Waterbridge Stateline Berdan Fed SWD#1

Berdan Fed SWD#1
(SWD-2570)

Application for Authorization to Inject
Well Name: Berdan Fed SWD #1

Berdan FED SWD #1
WaterBridge Stateline LLC
Sec. 8 Town. 20S Rng. 27E
Lat: 32.591602° Long: -104.295454° (NAD 83)

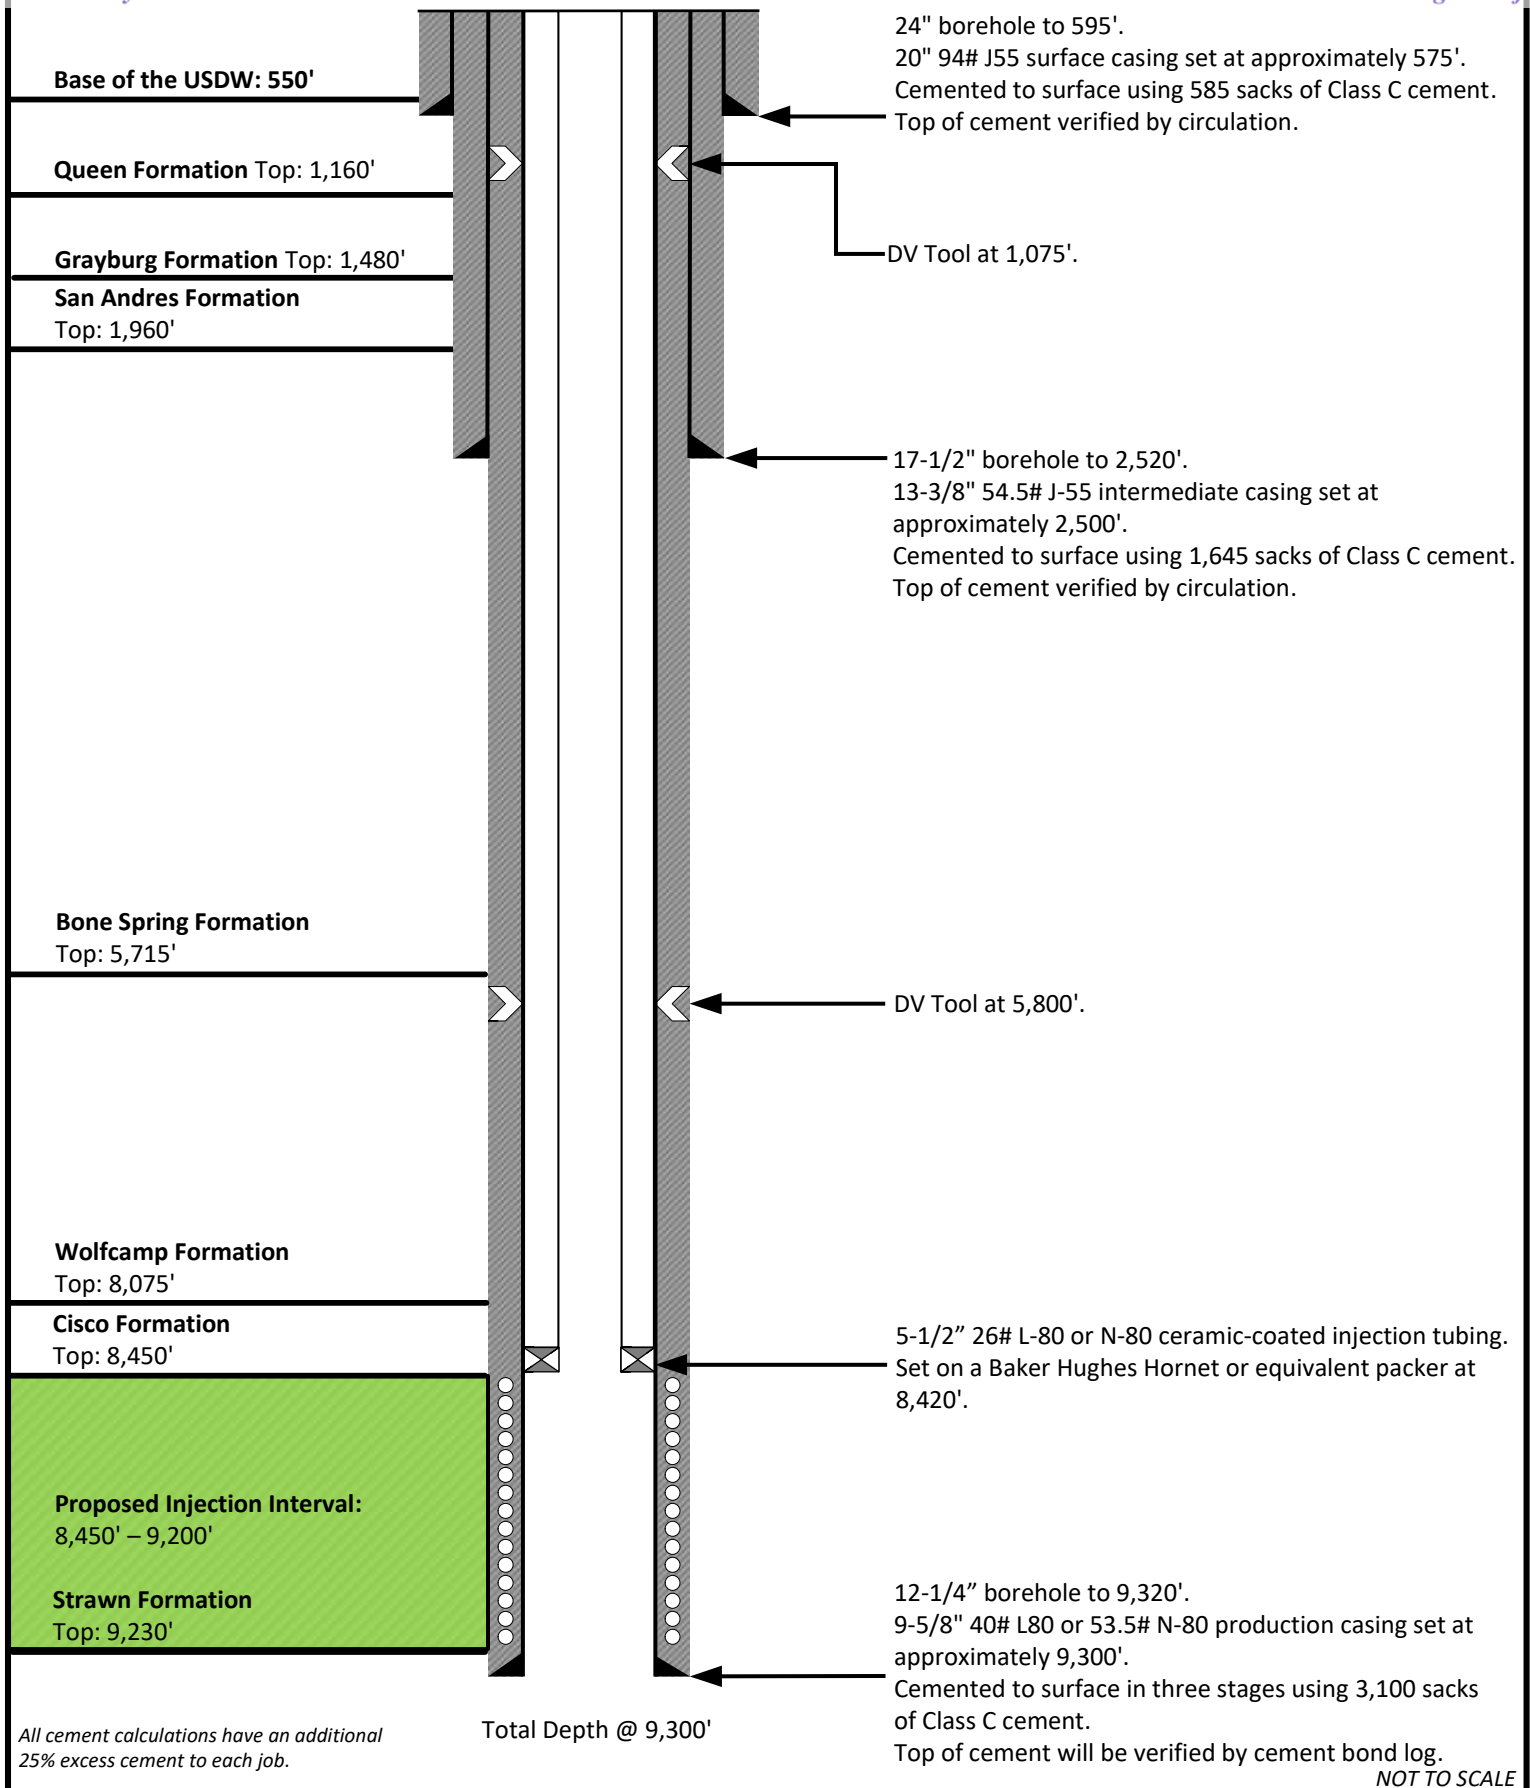
1. The Production casing must be cemented to surface.
 - a. Please update the wellbore diagram to reflect this requirement together with supporting details/documentation (eg. # sacks, DV tool location etc).

1. Injection is proposed into the Cisco.
 - a. Please provide a statement on the hydrocarbon potential (or lack thereof) for the Cisco formation in this area.
2. The 9-5/8" Production casing must be cemented to surface.
 - a. Please provide an updated wellbore diagram with cement to surface, DV tool depth(s), cementing details etc.
3. Figure 7 in your application shows a log from offset well API# 30-015-10298
 - a. Please provide a copy of that log including the log header information.

Please see the revised WBD and the revised supplemental information as requested.

Type	Hole Size	Casing Size	Casing Weight	Setting Depth	Sacks of Cement	Estimated TOC	Method Determined
Surface	24"	20"	94.0 lb/ft	575'	585	Surface	Circulation
Intermediate	17-1/2"	13-3/8"	54.5 lb/ft	2,500'	1,645	Surface	Circulation
Production Casing	12-1/4"	9-5/8"	40.0 lb/ft (L80) or 53.5 lb/ft (N-80)	9,300'	3,100	Surface	CBL
Tubing	N/A	5-1/2"	26.0 lb/ft	8,420'	N/A	N/A	N/A

DV Tool set at: 1,075' & 5,800'
